Re: Project Location CDDP24-03051 Bella Vista Apartments (Address: 2867 & 3105 WILLOW PASS RD, BAY POINT, CA 945653236), (APN: 093081027) Additional APNs: 093-081-027 (1.98 AC), 093-081-028 (0.509 AC)

**SUBJECT: Bay Point Affordable Multi-Family Project (LP22-02029)**

To: Adrian Veliz Planner  
From: Christine Louie, Planner  
Date: June 20, 2025  
Subject: **County File #CDLP22-02029, 2855-2867 Willow Pass Rd. Bay Point, CA 94565**  
Second Agency Comments Response  
Project Name: **Willow Pass Apartments**

**Figure 1: CDDP24-03051 Vicinity & Alquist-Priolo Map**

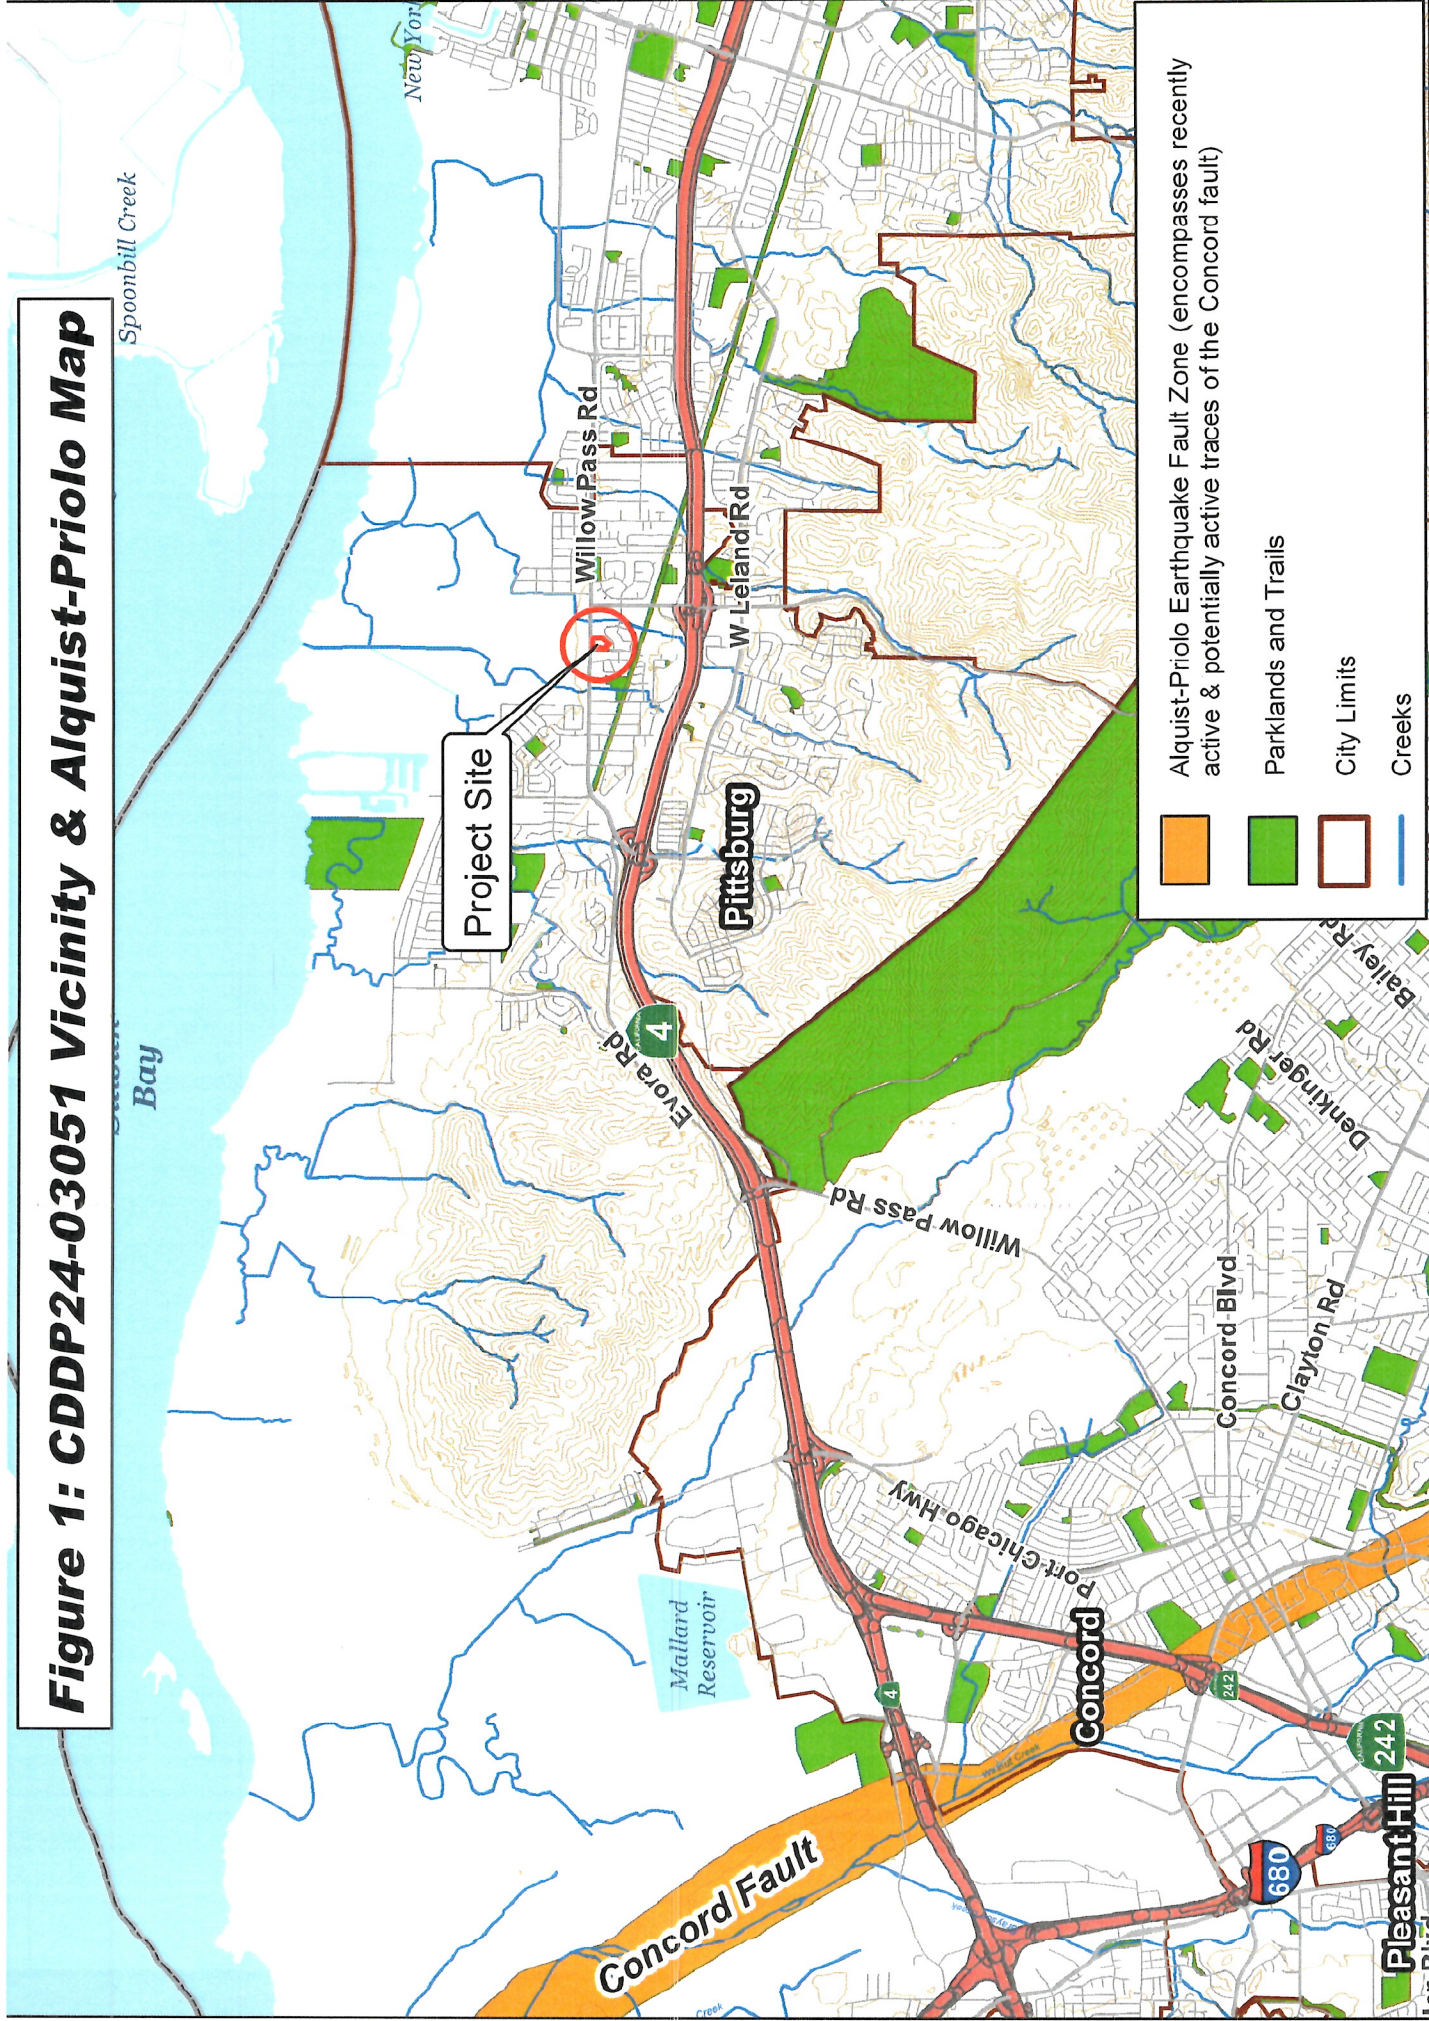
Figure 1, Vicinity and Alquist-Priolo Map, shows the location of the site with respect to major roads, major open space areas (shaded green), intermittent / perennial creeks, as well as Honker and Suisun Bays (shaded blue). The boundary of the project site is located within the Pittsburg-Antioch Plain. This plain slopes gently to the north, and elevations on the site slope 64 to 73 ft., with the slope of 2% toward Honker Bay. A few hundred feet south of the site is State Route 4, which is located at the toe of a northwest-trending ridge named the Los Medanos Hills. For reference purposes, Figure 1 also shows the location of the Alquist-Priolo (A-P) Earthquake Fault Zone that encompasses recently active and potentially active traces of the Concord fault. This northwest-trending fault zone is shaded orange and passes 6 miles southwest of the project site. Figure 1 also shows the boundaries of nearby cities (brown line). Architectural drawings prepared by Y&M Architects
